発行No : LC 23512R03 -1/1
発行日 : 2023年5月18日
シャープディスプレイテクノロジー株式会社
事業本部
MIA事業部 開発部

表面処理「AG」偏光板採用メモリLCDモジュールの変更に関するお知らせ

Notice of change in "AG" surface front polarizer of the Memory LCD Module.

Nitto AG Polarizer for Mono Memory LCD Model EOL Report

1. Mono Memory LCD Model Top Polarizer Stack-up

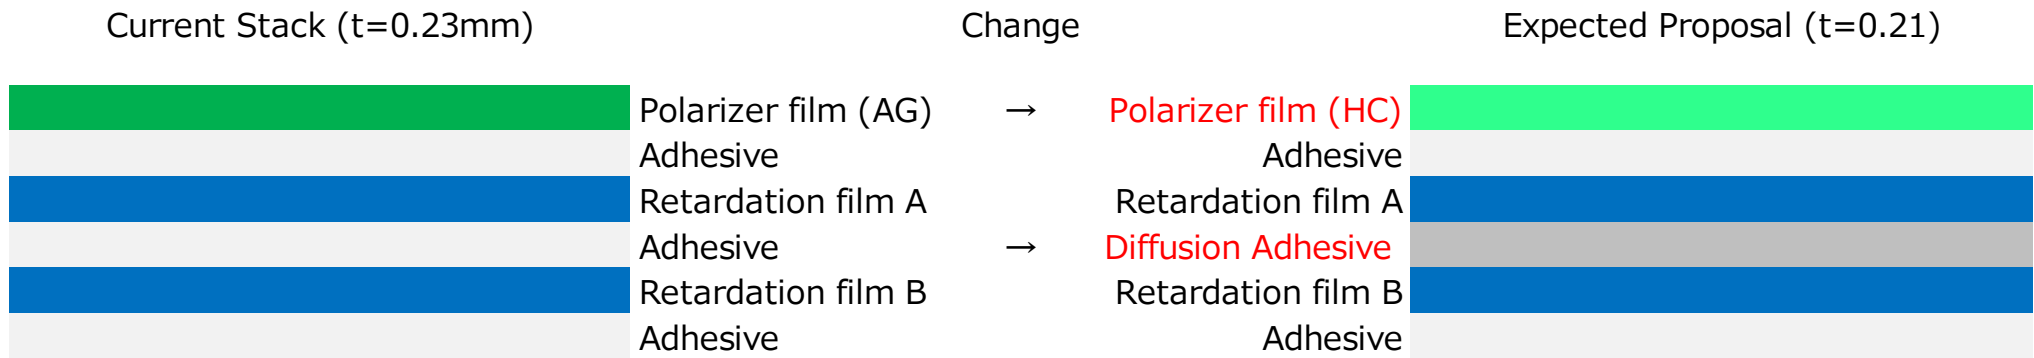
- Model : All Mono memory LCDs except LS012B7DD01, LS012B4DG01, and LS032B7DD02
※Refer to the Model list
- Contents : Change of polarizer surface treatment and Adhesive type
※Anti Glare(AG) ⇒ Hard Coat(HC)
※Adhesive(3layer) ⇒ Adhesive(2layer) + Diffusion Adhesive(1layer)
- Reason : EOL for materials
- Expected change date : Switch from about Oct 2024
*Varies depending on polarizer stock.
- Spec/Reliability : There will be change in Surface Treatment("AG"⇒"HC") and Front Pol tickness(about▼0.02mm).
No change the optical spec value and reliability of the LCD modules.
- Others : The Actual appearance is different due to surface treatment change.
*New Pol samples be plan to sent after Sep 2023.

- Mono models are a change in surface treatment (AG to HC) and added diffuser.
- This values are almost the same, and we consider that there is no need to change the specification values.

All Model No change in Optical Spec Values.
